# IBC - Fire Safety

## 2024 GROUP A PROPOSED CHANGES TO THE I-CODES

# 2024 GROUP A – PROPOSED CHANGES TO THE INTERNATIONAL BUILDING CODE – FIRE SAFETY

Figure 1 – Current code allows fire to go around the fire barrier

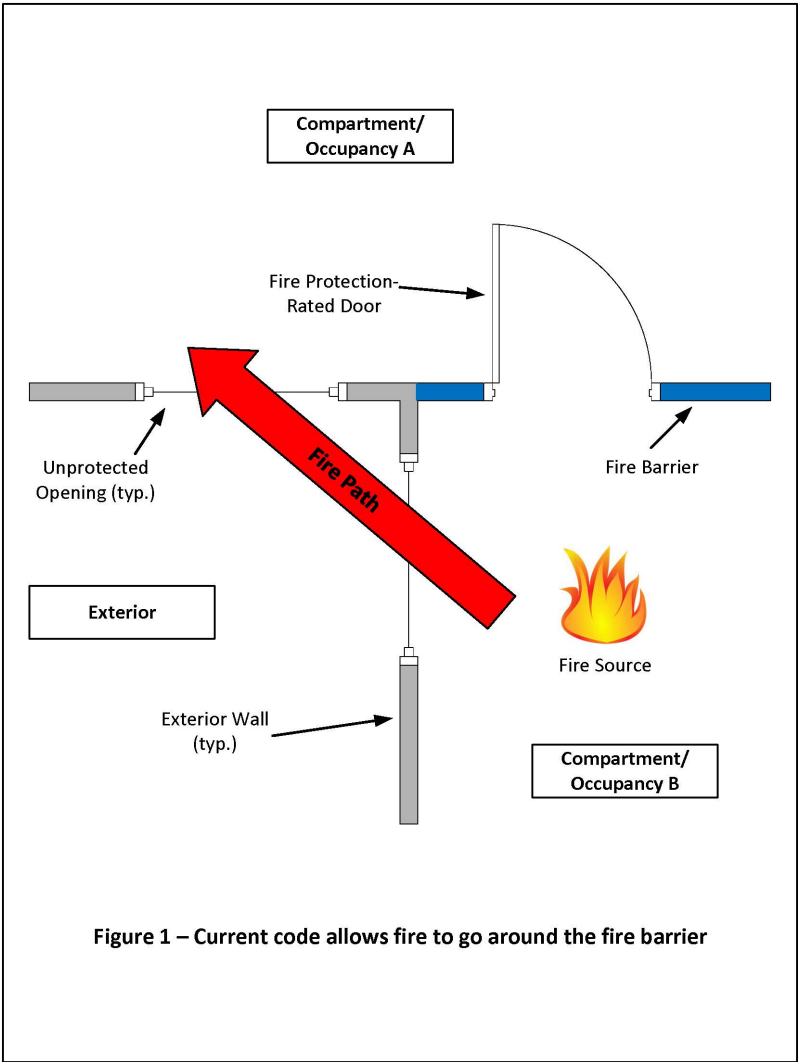
This code change proposal addresses these issues by requiring either 4-foot "wings" on either side of the fire barriers (Section 707.4.2, Item 1) or fire partitions (Section 708.5.1, Item 1) or providing exterior wall ratings and opening protection required by the location of an imaginary property line (Item 2 of each section). Figure 3 shows an example of how this can be done for the fire barrier scenario shown in Figure 1 but could be applied to fire partitions as well. The proposed language is based on the parallel requirements for fire walls and only applies where the exterior walls form an angle of less than 180 degrees. It also does not apply to exterior walls for fire-resistance-rated *shafts*, or separation or enclosure for a *stairway*, *ramp* or *exit passageway*.

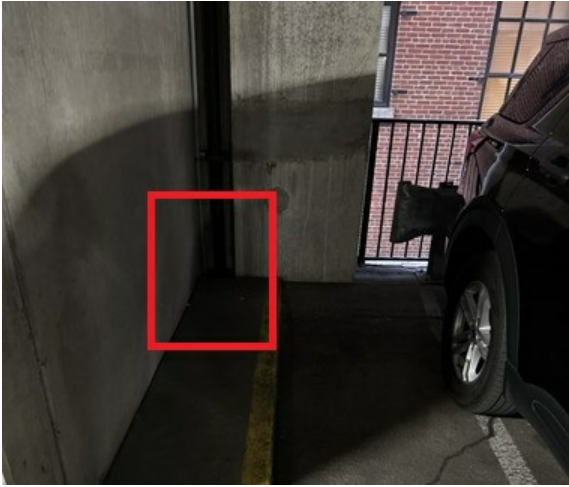
The photos below show an example of a parking garage penetration. These photos were taken at the Marriott St Louis Grand Hotel multi-story parking garage. An approximate 12 in. by 12 in. opening was located approximately 4 ft from an adjacent parked car. By the 2024 IBC, this unprotected opening is permitted. Is the level of protection we should be permitting?

**FIGURE 1402.3 Wind-driven rain wind speed (m/s) hazard map to determine ASTM E331 test pressure criteria [1 m/s = 2.24 mph]**

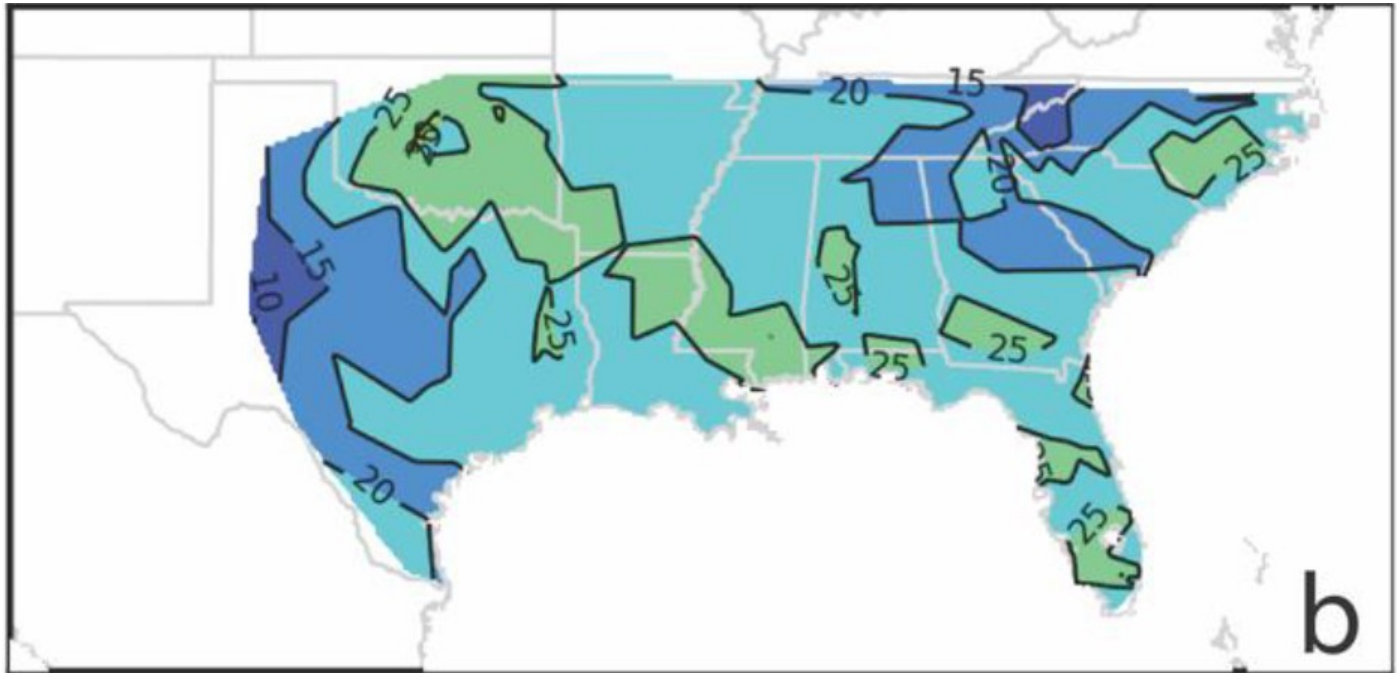
1. The ASTM E331 test pressure shall be determined in accordance with Table 1402.3 and Figure 1402.3 or by calculations in accordance with ASCE 7 using a design wind-driven rain wind speed in accordance with Figure 1402.3. The test pressure shall not be less than 2.86 psf (137 Pa) and shall not be required to exceed 12.0 psf (575 Pa).
2. The duration of test shall not be less than 15 minutes. Subsequent tests with increased test pressure shall be permitted with leakage assessment after each test.
3. The tested assembly shall be considered to resist wind-driven rain at the greatest test pressure increment where water did not penetrate the innermost layer intended to provide water resistance protection of the remainder of the wall assembly.

**Reason:** The code lacks a risk-consistent basis for addressing wind-driven rain and resistance to water intrusion. This proposal provides a wind-driven rain hazard map (Figure 1402.3) that properly characterizes the hazard as it varies across wind-driven rain climatology of the U.S. This map of the southeastern U.S. is a placeholder until a map of the entire U.S. becomes available in 2024.
